**DEVIATION REQUEST** (Attach diagrams, figures, and other documentation to clarify request)

A deviation from the standards of or in Section 2.5.2.C.4 of the Engineering Criteria Manual (ECM) is requested.

PROJECT:  
**ANTELOPE RIDGE AT BULL HILL  
 PUD AND PRELIMINARY PLAN**  
 EL PASO COUNTY, COLORADO  
 AUGUST 2025

### DEVIATION EXHIBIT

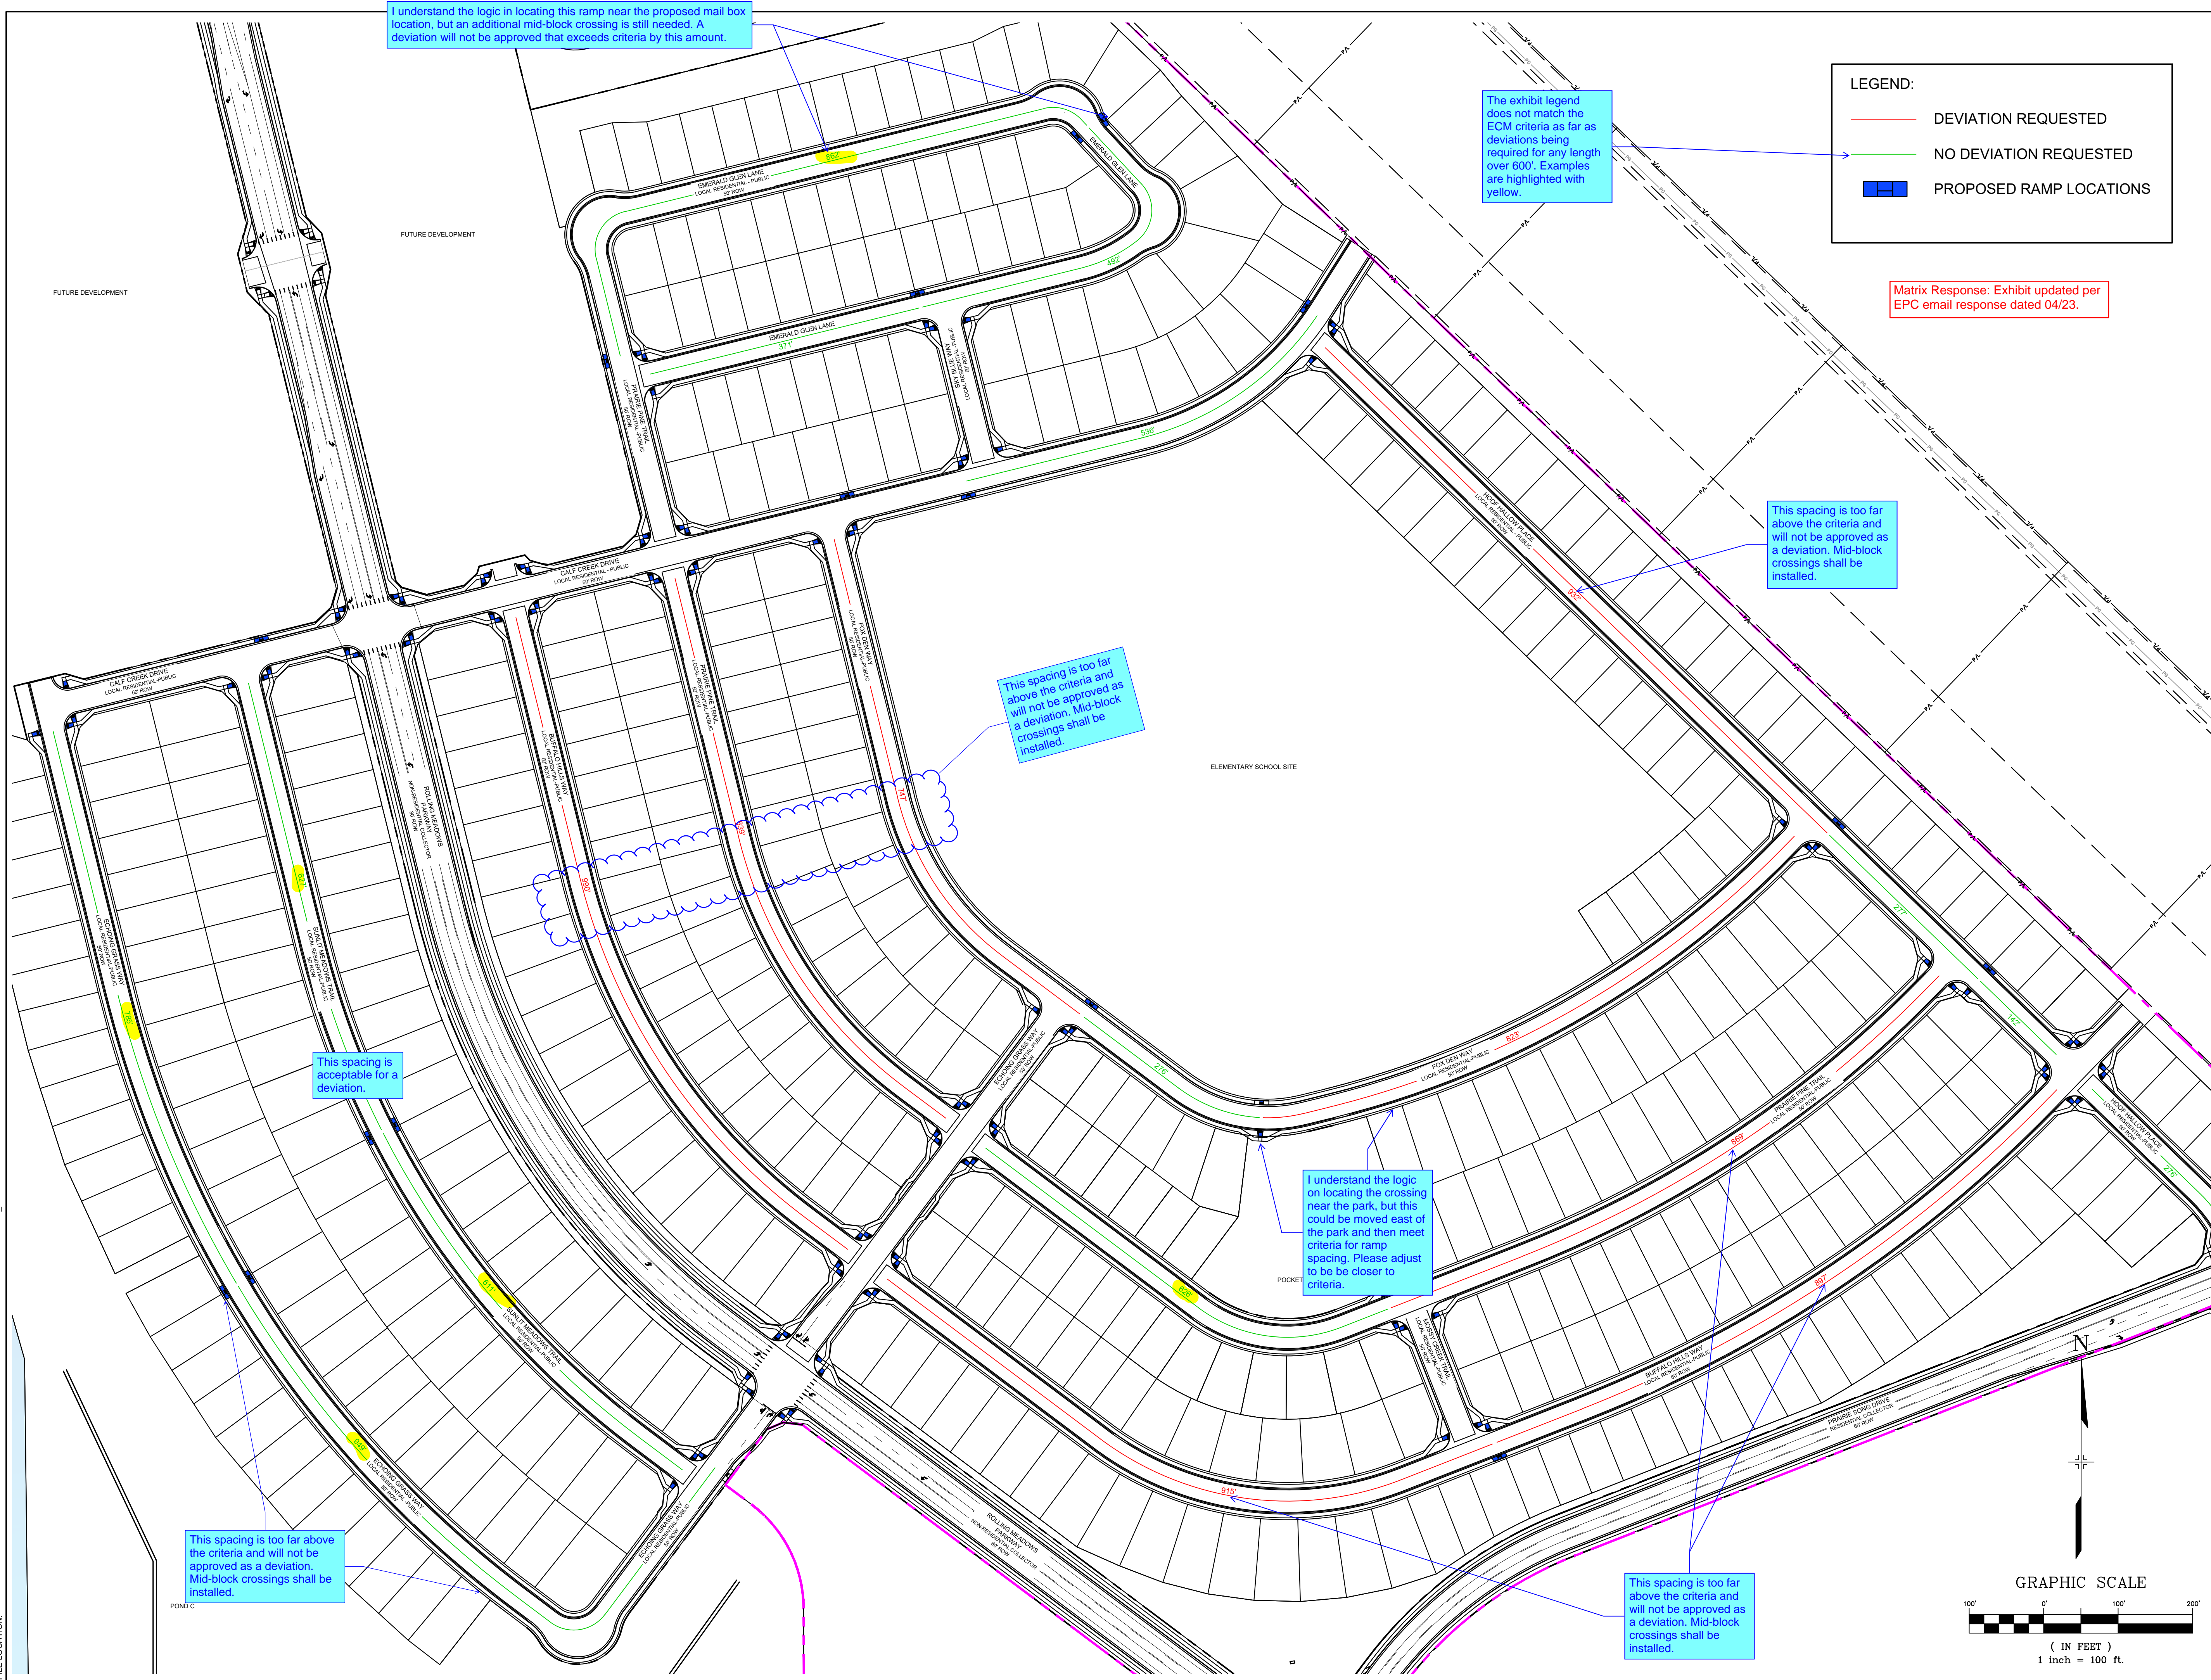
I understand the logic in locating this ramp near the proposed mail box location, but an additional mid-block crossing is still needed. A deviation will not be approved that exceeds criteria by this amount.

The exhibit legend does not match the ECM criteria as far as deviations being required for any length over 600'. Examples are highlighted with yellow.

This spacing is too far above the criteria and will not be approved as a deviation. Mid-block crossings shall be installed.

This spacing is too far above the criteria and will not be approved as a deviation. Mid-block crossings shall be installed.

This spacing is acceptable for a deviation.

I understand the logic on locating the crossing near the park, but this could be moved east of the park and then meet criteria for ramp spacing. Please adjust to be closer to criteria.

This spacing is too far above the criteria and will not be approved as a deviation. Mid-block crossings shall be installed.

This spacing is too far above the criteria and will not be approved as a deviation. Mid-block crossings shall be installed.

Matrix Response: Exhibit updated per EPC email response dated 04/23.
